**City of Ketchum
Planning & Building**

IN RE:)
)
Sawtooth Serenade) **KETCHUM PLANNING AND ZONING COMMISSION**
Design Review) **FINDINGS OF FACT, CONCLUSIONS OF LAW, AND**
Date: February 5, 2026) **DECISION**
)
File Number: P24-027)

PROJECT: Sawtooth Serenade

APPLICATION TYPE: Design Review

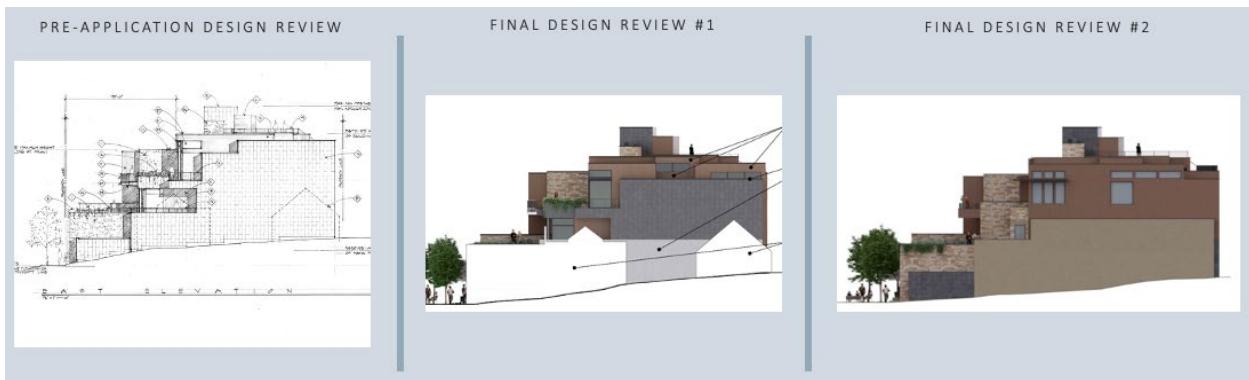
Finding: During the review of the preapplication, the Commission expressed concerns related to the bulk and flatness of the building due to the amount of glazing, the length of the building, and the repetitive nature of the architectural design on the 2nd and 3rd floor levels. The Commission specifically noted the extent of the horizontal elements of the building and the mirroring of the north and south portions of the building that created the appearance of one large, long, flat building. The Commission requested the applicant take a closer look at how the building could be broken up to reduce the bulk and mass of the structure, including the recommendation to design the project as if it were two separate buildings with different design approaches. As the subject property is three Ketchum Townsite lots, and the building is maximizing the allowable north/south footprint, the resulting building is 165 feet long on the N 1st Ave side. The Commission acknowledged the challenge of reducing the bulk and mass of a building of this size and noted that the reduction of bulk and mass of buildings spanning three Ketchum townsite lots is critically important for new development, more so than developments on a single or double Ketchum Townsite lot, and that unique design approaches may be necessary to effectively reduce the appearance of the bulk and mass of the building.

In the first design review hearing, the Commission repeated comments related to the bulk and mass of the structure noting that although there is a wedding cake approach to the building from front to back (1st Ave to the alley) the building does not deploy a successful approach in reducing the bulk and mass from north to south (Sun Valley Rd to 2nd St). The proposal still appeared as one long, flat building primarily due to the long horizontal cantilevered decks, large windows, and long flat rooflines that were mirrored on the north and south portions of the building flanking the central staircase. The Commission found that the symmetry and banding and flat roof lines of the building exacerbate the bulk and mass of the building and efforts to reduce the bulk and mass by simply removing small amounts of square footage from the building at the corners were not effective. The Commission again requested the applicant revise the design approach to better match the context of the surrounding area by creating the appearance of multiple buildings. Below are images of the three design iterations of the west façade (N 1st Ave). The first image is the pre-application design review, the second image is the revised proposal presented in February 2025, and the third image is the final design proposal.

As clearly shown in the images above, the repetitive nature of the horizontal features including the cantilevered decks, flat rooflines, and amount of windows did not dramatically change from the first proposal to the last and did not address the Commission's concerns about how those features contribute to the long and flat appearance of the building. The Commission found that the Applicant did not sufficiently evaluate the option of designing two separate buildings attached by a center party-wall and that the minor changes to where certain materials were applied, addition of sunshade awnings, further stepback of sections of the façade, and removal of certain decks did not address the concerns related to the bulk and flatness of the building as viewed from N 1st Ave.
